Advantech AE Technical Share Document

Date	2018 / 05 / 28	SR#	1-3972266450
Category	■FAQ□SOP	Related OS	N/A
Abstract	[Notification] UNO-2473G-J doesn't have the terminal resistor switch for adjusting		
Keyword	Terminal resistor, UNO-2473G-J		
Related Product	UNO-2473G-J

Figure A.2 UNO-2473G Connector & Jumper Locations (front)

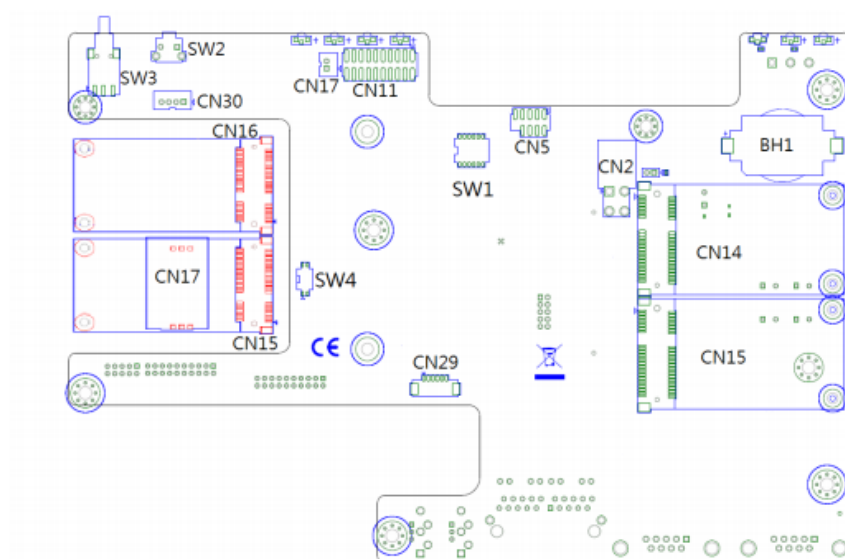
Correct the User Manual information: Only **UNO-2473-E3AE** has the SW1 to adjust terminal function
UNO-2473G-J COM 3 & COM 4 don't have the switch to adjust. The default RS-485 terminal resistor is enabled.
